8 November 2018, revised 31 July 2020 and 27 November 2020

Steve Pattinson  
President  
Save Our Hills (Upper Hutt) Inc  
Hutt Valley  
Wellington

### Assessment of the Pinehaven Stream 23 July 2009 flood peak.

Figure 1: Flow gaugings available and the problem with extending the rating curve without high flow gaugings.

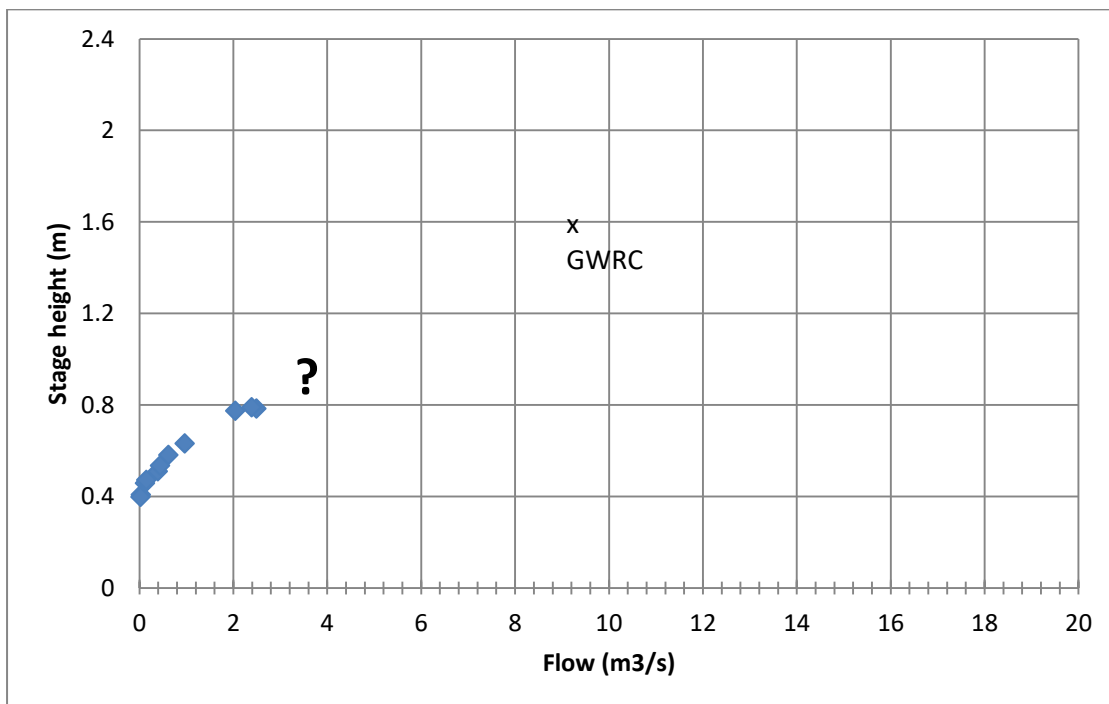
The problem for the GWRC hydrology team was how to extend the rating curve from 0.8 m to 1.6 m Figure 1, due to the lack of high flow measurements. The lack of any flood measurements or mapped flood marks during the peak of the 23 July 2009 is disappointing as the capture of flood measurements for flood design purposes is the main reason for the flow recorder site on Pinehaven Stream opposite Chatsworth Road.

High flow gaugings will give key information for extending the rating curve to provide accurate values of the peak flood. Unfortunately one gauging was completed the day after on 24<sup>th</sup> July but the flows had receded considerably to only 0.44 m<sup>3</sup>/s. An attempt was made on 30 August 2009 to measure high flows to define the top end of the rating however stage height levels measured were less than 0.8 m, some 0.77 m less than the 1.577m peak measured on 23 July 2009 peak.

**Figure 2: Pinehaven Stream flood hydrograph for 23 July 2009 and single gauging of 24 July 2009 (red diamond).**

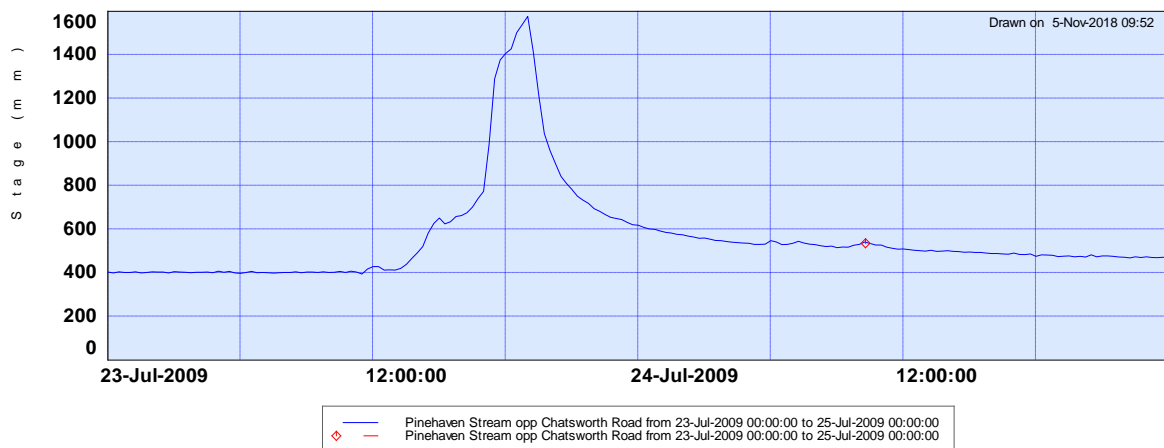
Plots of the 23 July flood hydrograph with the gauging plotted are displayed on Figure 2 and the 30 August peak with three gaugings plotted are shown on Figure 3.

**Figure 4: Pinehaven Stream at Chatsworth road stage height versus mean velocity curve**

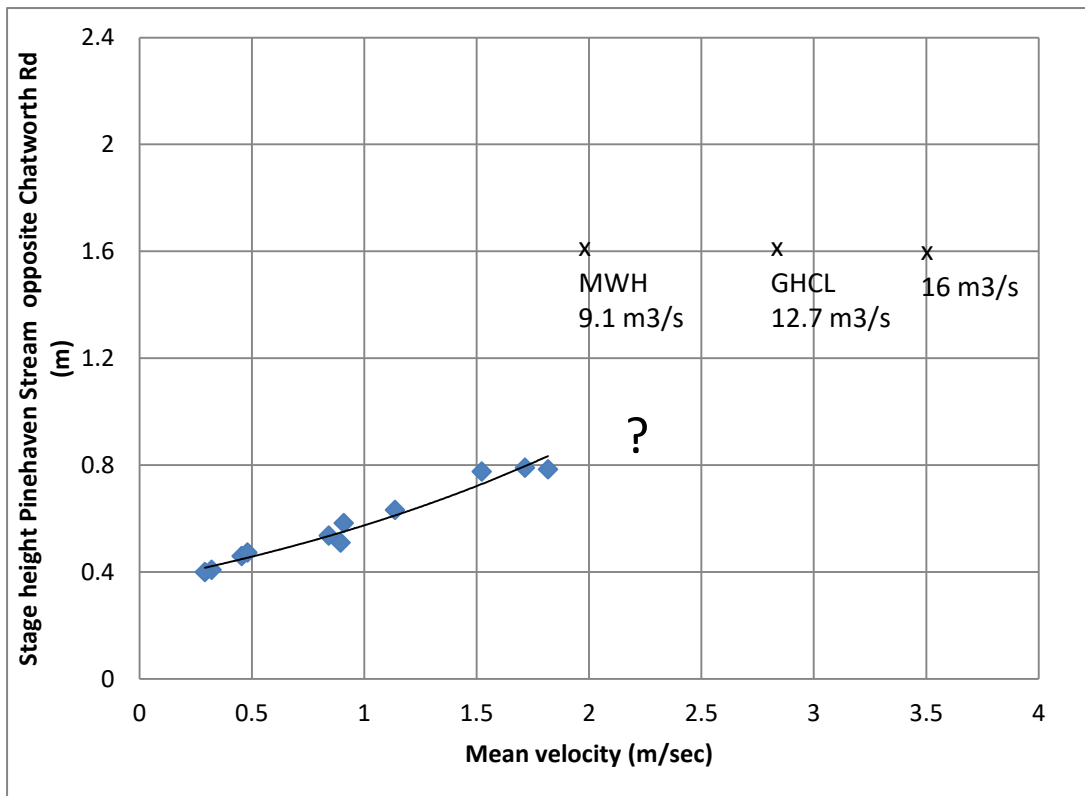
Figure 4 displays the problem with extending the stage/velocity curve between 0.8 m and 1.6 m. The MWH approach was to adopt 2 m/sec at stage 1.6 m. However this is only a 10 % increase in mean velocity from the stage of 0.8 m. This is not plausible in such a smooth bedded and smooth walled channel. My estimate is 2.8 m/sec which would result in a 12.7 m³/sec flow at 1.6 m, however for a flow of 16 m³/s a mean velocity of 3.51 m/sec would be required.

My estimate of the flow peak at 1.577 m on 23 July 2009 is 12 m<sup>3</sup>/s, however future high stage gaugings to define the stage/mean velocity curve would provide higher confidence to estimates. I consider the 8.8 m<sup>3</sup>/s an underestimate. Interestingly the SKM (2010) report of modelling the 23 July 2009 event shows a peak discharge of approximately 11.8 m<sup>3</sup>/s, but unfortunately their depth at the staff gauge is 400 mm less than that actually measured ( the only actual measured data point in their modelling), a gross error. This highlights the risk of using just one single event to calibrate the rainfall runoff model, which then feeds inputs into the hydraulic model. Multiple flood events should have been used in the calibration with additional floods for the testing/verification phase.
